Interactive comment on “A new fractal-theory-based criterion for hydrological model calibration” by Zhixu Bai et al.

Zhixu Bai et al.

Received and published: 1 February 2021

Fig. 1. Fig. R2-4

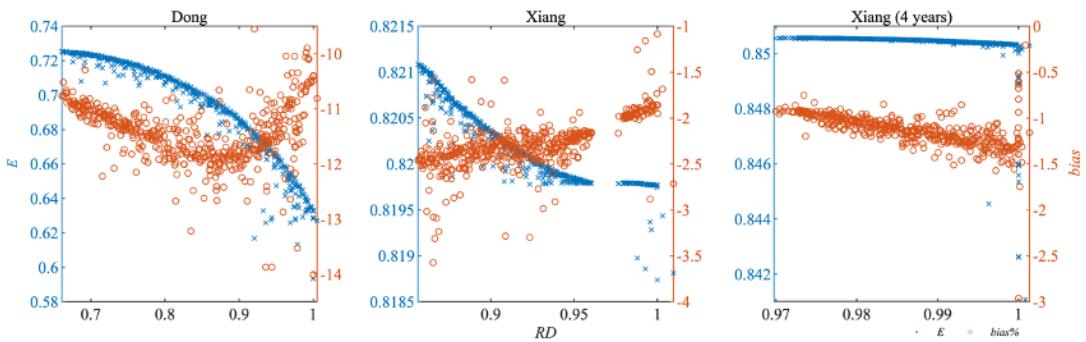
4. L190-206: The authors use data from three catchments with different sizes and different data periods (and lengths of time series). In particular, the data period for the Dong catchment is short (4 years) compared to the other two catchments. What is the influence of these differences in data periods on the results? Does it explain the relatively poor performance of the HBV model for the Dong catchment compared to the other two catchments, particularly for fast and slow flow? Did the authors test their framework with equal data periods for the three catchments (i.e. for Jinhua and Xiang also 4-year time series)? This would be a useful test to isolate the influence of difference lengths of data periods.

Thanks for your kind comment and advice. We made a comparison of the modeling performance based on 4-year time series, and the results are shown below.

Fig. R2-4 Comparison of the E-RD strategy with 4-year data and whole period in Xiang case.

Fig. R2-4 will not be put in the manuscript. According to Fig. R2-4, the E-RD strategy would not change its behavior with the lengths of data in our study. The relevant description will be:

“To get rid of the possible influence of the lengths of time series, a comparison of the multi-objective calibration with the same length of data is made. The results show that, at least in the cases of this study, the E-RD strategy would not change its behavior with the lengths of data.”

Fig. 2. Fig. R2-8

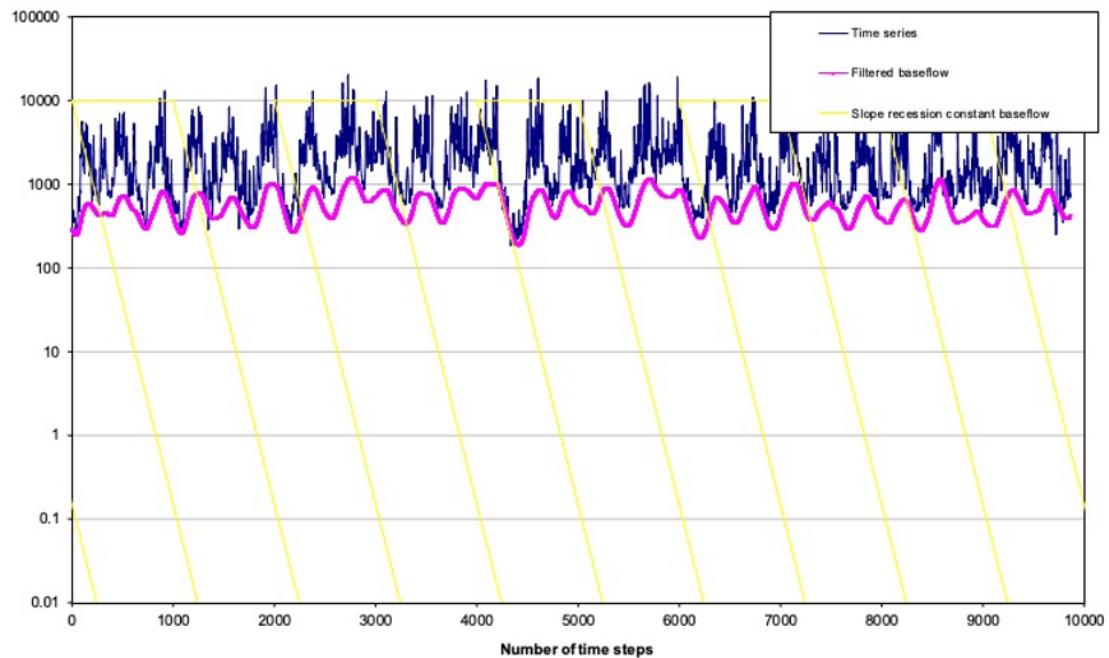
8. L283-285: The authors compare observed and simulated fast flow and baseflow. Observed components have been obtained using the WETSPRO tool. However, it is unclear how well the division into streamflow components is done by this tool (also mentioned by the authors in sub-section 4.3). It might well be that observed and simulated components describe a (totally) different flow mechanism. For the Dong catchment, this results in a poor performance for streamflow components and for the other two catchments in a good performance. What is the principle used by WETSPRO to separate flow components and to what extent is that principle related to the concepts of the HBV model? This needs more discussion by the authors.

The WETSPRO could separate the streamflow into fast flow and slow flow first, and then separate the fast flow into overland flow and interflow. In our study, only the first

step is applied and only the first-step-related parameters of WETSPRO are listed in the table below. We selected the parameters by following the procedure. In WETSPRO's procedure, the parameters are selected one by one. For each parameter/step, there is a corresponding criterion. Thus, the separated streamflow components are relatively comparatively objective. Fig. R1-5 is an example of the objective procedure of selection. In this step, the user selects the w-parameter filter, which represents the case-specific average fraction of the quick flow volumes over the total flow volumes. According to the literature, the filtered baseflow should be close to the total streamflow in dry periods (Willems, 2009). The selection can be considered relatively objective.

Fig. R2-8 An example of the objective procedure of selection. The methodology uses multiple and non-commensurable measures of information derived from the river flow series by means of a number of sequential time series processing tasks. It's derived from the recursive digital filter(Willems, 2009). To briefly introduce the characteristics of WETSPRO to our readers, we would add the following description in Section 3.4:

“WETSPRO separates fast flow and slow flow on the basis of filter theory, using several filter parameters including recession constant, average fraction of fast flow volumes over the total flow volumes, etc.” We applied the WETSPRO tool to observed and simulated streamflow series. In this way, the standard of separating streamflow into components could be the same for observation and simulation. We added the following sentence to explain this in sub-section 4.3:

“The simulated total flow is also separated with the WETSPRO tool to make the principle of separation of simulation and observation same.”
